CITY OF ALBUQUERQUE

RE: 9050 Alameda Blvd NE
Grading and Drainage Plan Stamp Date: 2/20/19
Drainage Report Stamp Date: 2/20/19
Hydrology File: C20D077

DRAINAGE REPORT
FOR
LOT 16, BLOCK 4, TRACT 3, UNIT 3
NORTH ALBUQUERQUE ACRES

La Cueva - Revised Model V2 Plan: Existing Conditions 2/19/2019 2:19:23 PM

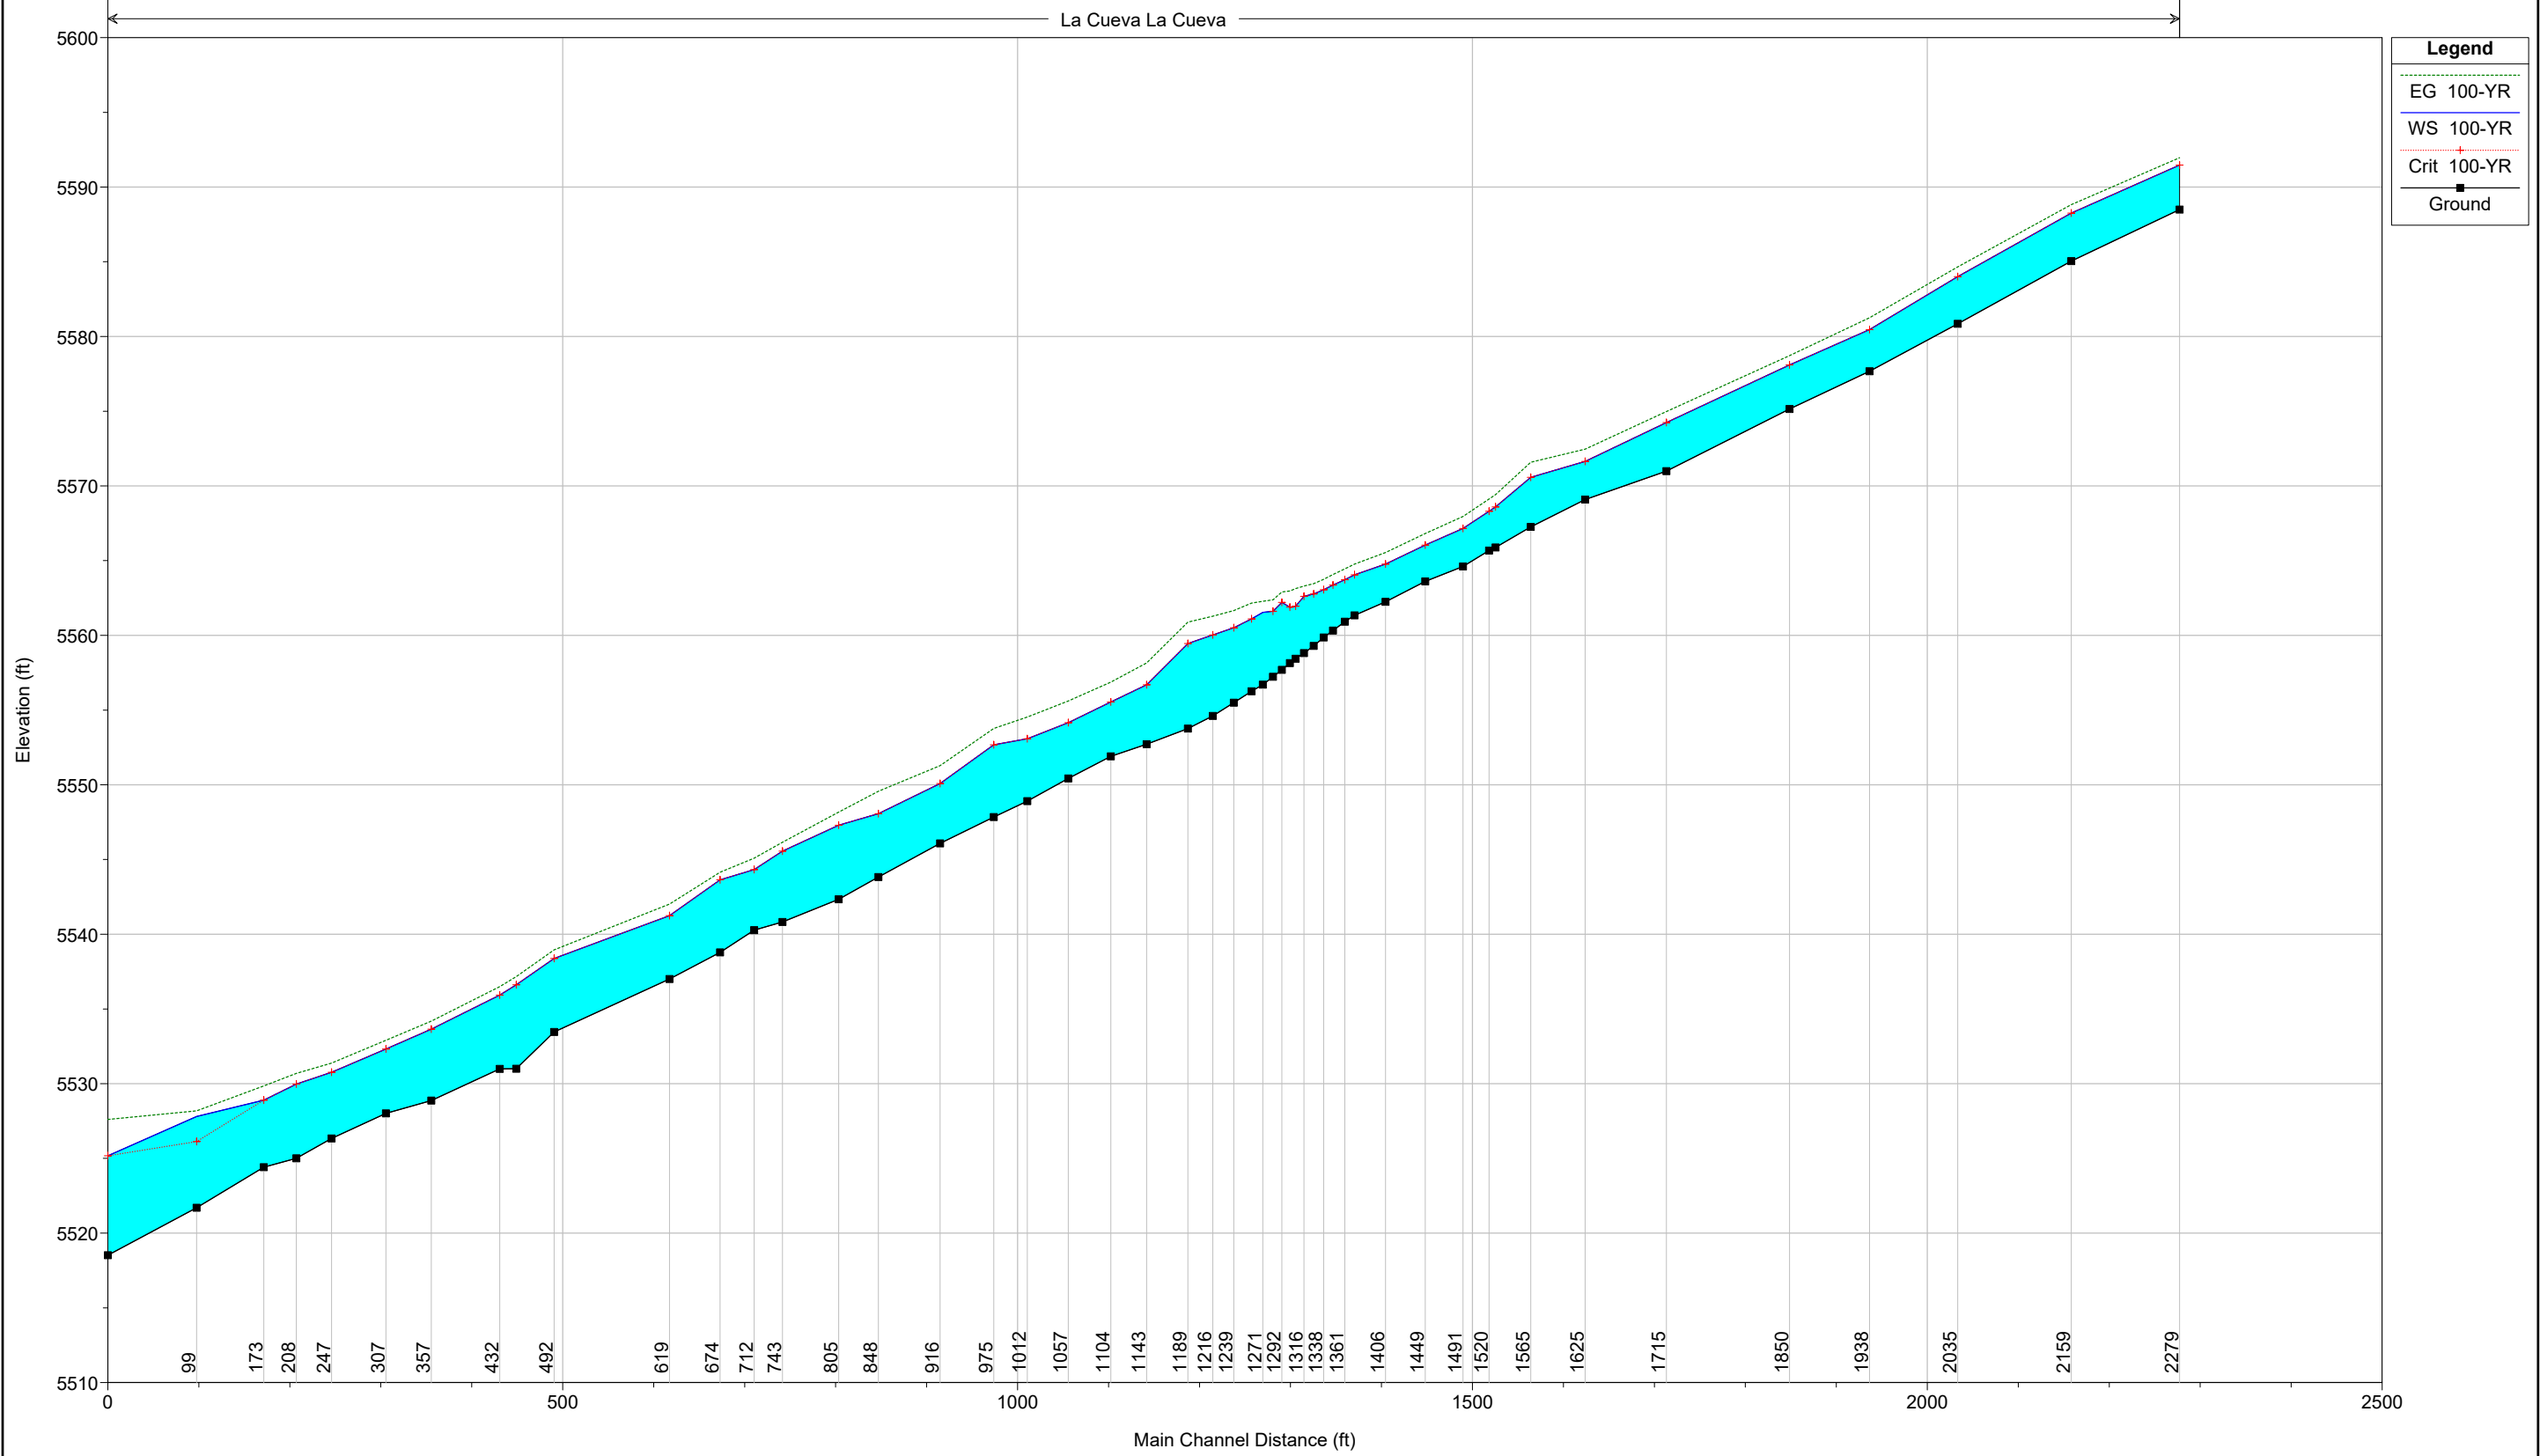
- iii. The Corrected Effective model is modeling the ineffective flow area at the contraction upstream of the existing subdivision too gradually and the encroachments are being overtopped. The contraction angle should be 45° or more measured from the new centerline above. Elevations should not be specified on the encroachments to avoid overtopping.

- iv. The grades in the Proposed HEC-RAS model at section 1527 are different than what is shown on the grading plan. Both the grading plan and the HEC-RAS section must be fixed to show the grades in

LOT 16 SOUTH SCOUR WALL

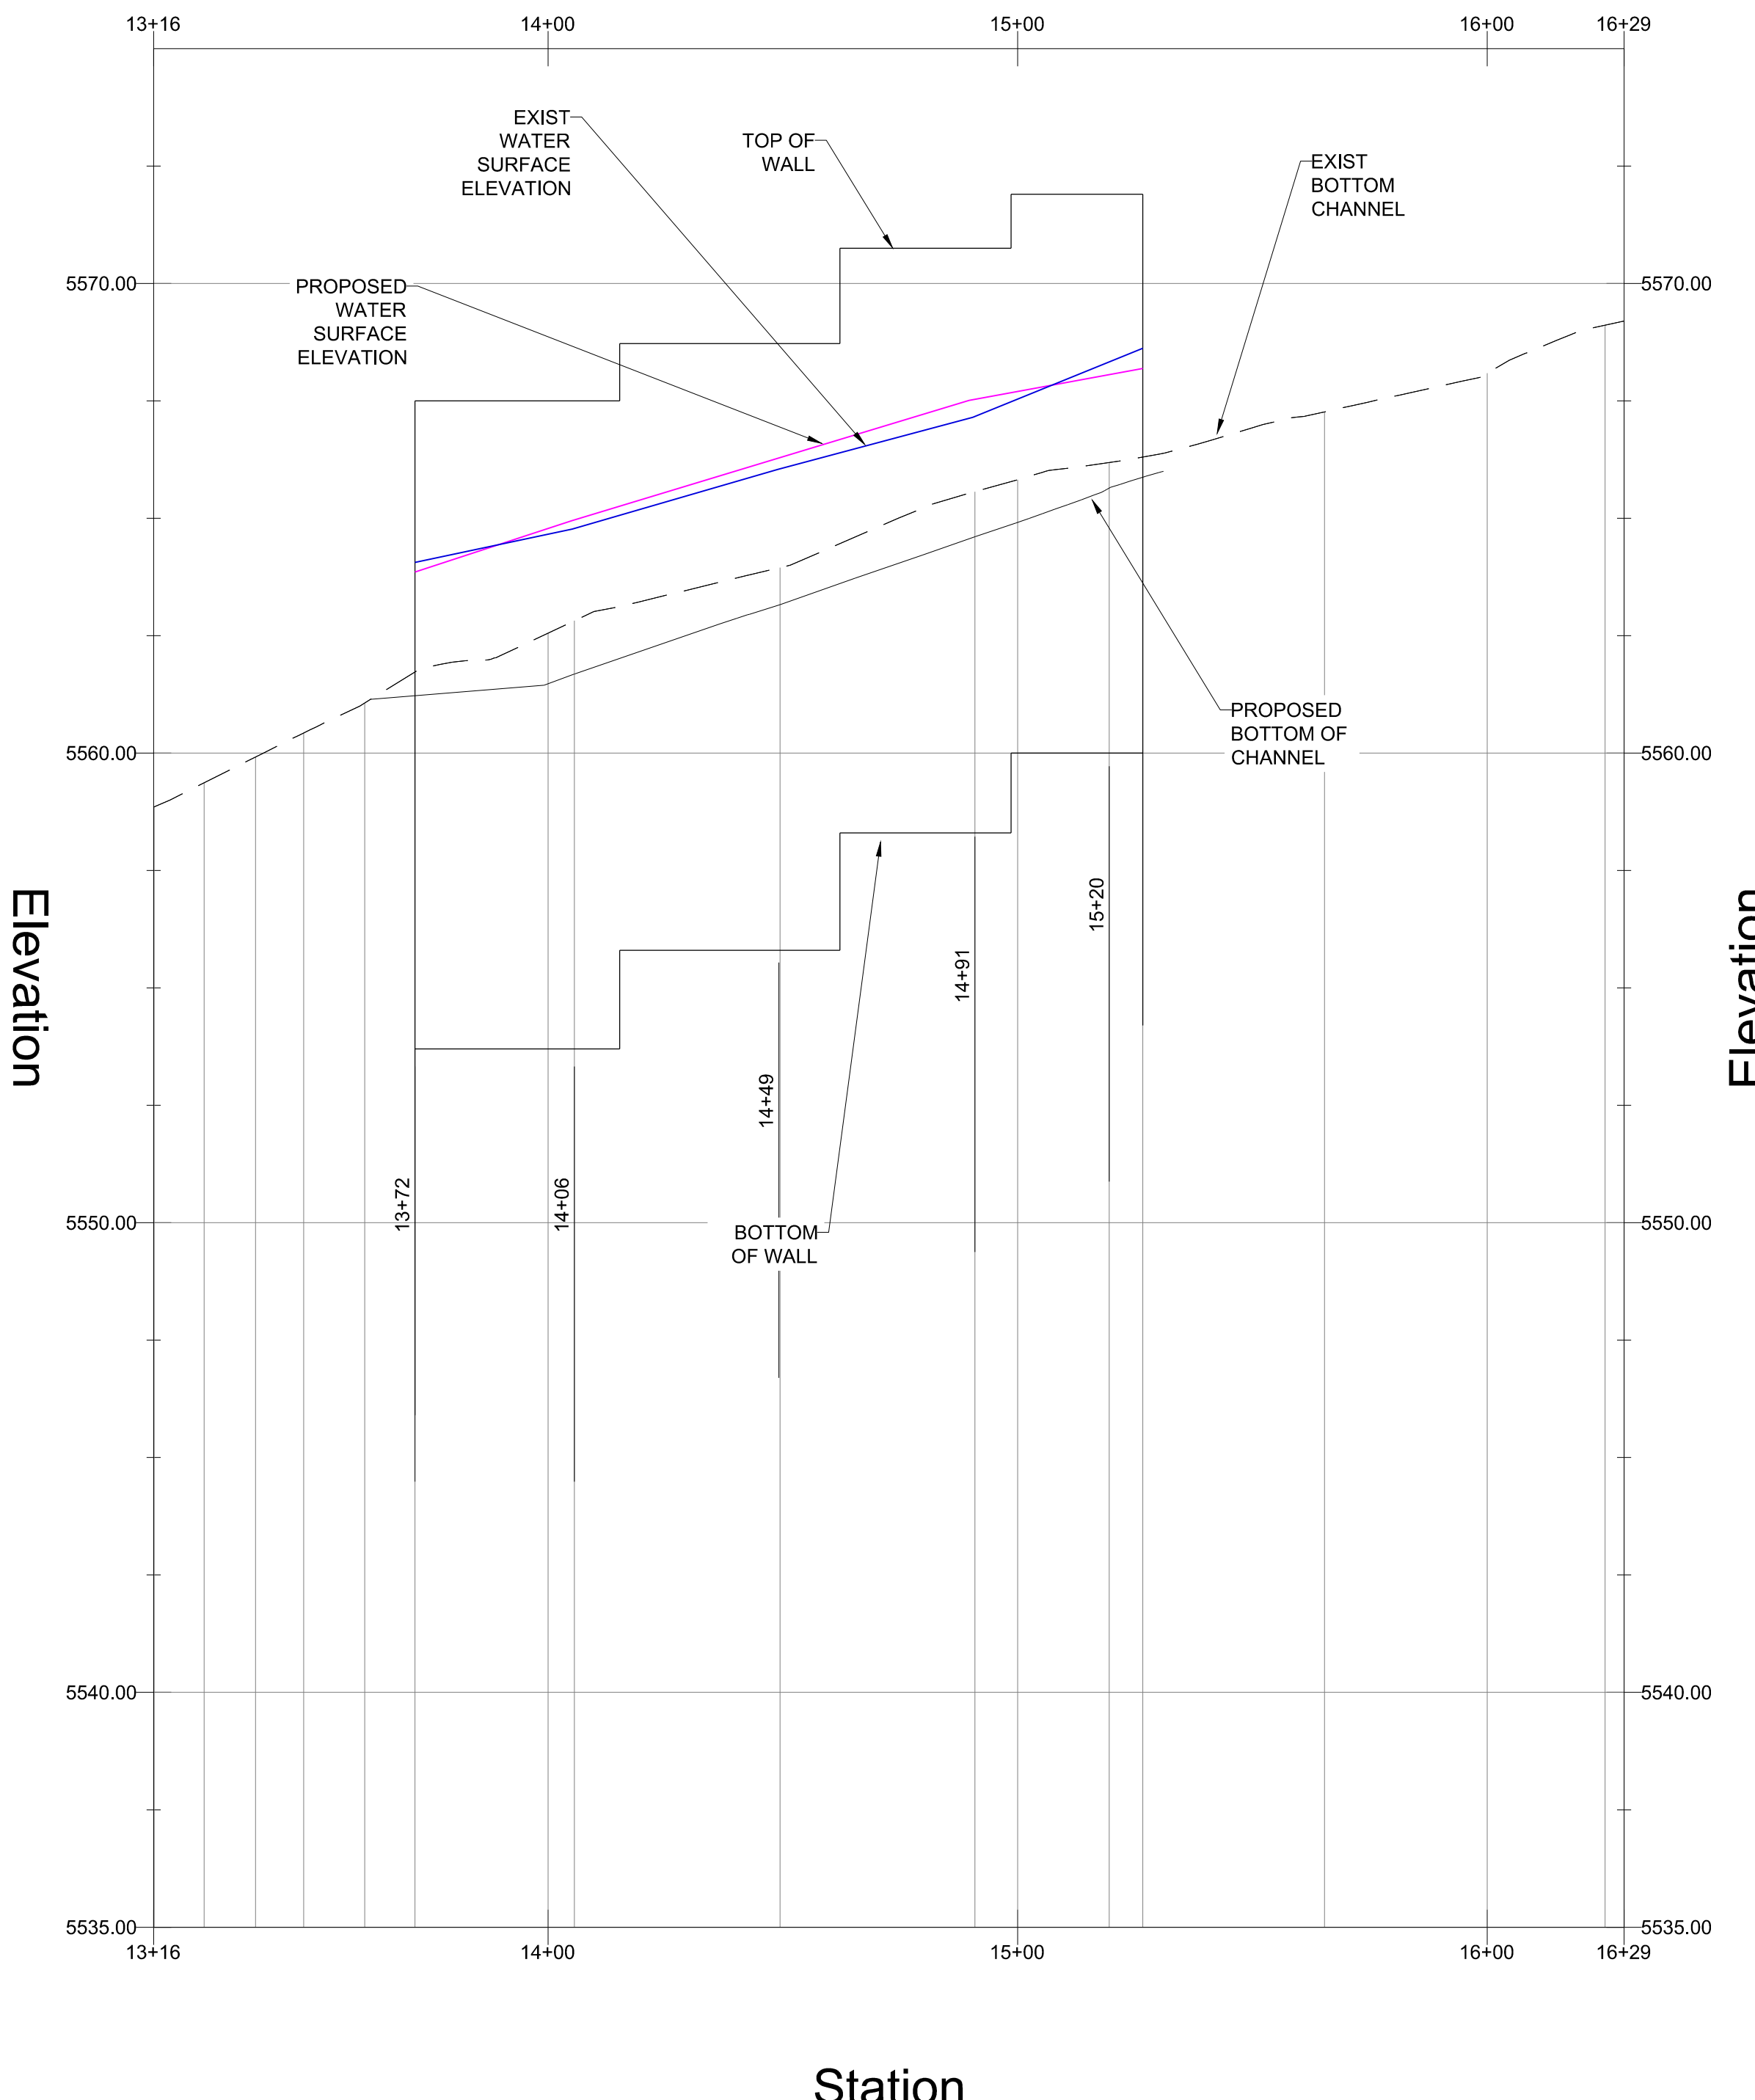
4. Scour Wall design calculations and details are required including scour depth calculations, freeboard calculations, and super-elevation calculations. Include all calculations computer models and excel spread sheets not merely a summary table. The HEC-RAS results in Scour Depth calculation table do not agree with the HEC-RAS tables in the report or with the computer model even when it is run mixed. The scour depths that I calculate using the HEC-RAS model mixed is about one foot deeper using the parallel flow equation. Use equation 3.88 for the wall on the east side of this lot. Revisions to the HEC-RAS model should be made before updating these calculations as there seems to be major disagreement between the Channel width measured on the plan and the top width from the HEC-RAS model because the sections are skewed instead of perpendicular to the flow.

- a. The footing of the scour wall looks too small. The footer has to support the wall after the soil is removed from the low side to the scour depth. Please provide structural calculations including loading assumptions stamped by a registered professional engineer to accompany the wall details shown on the G&D sheets.
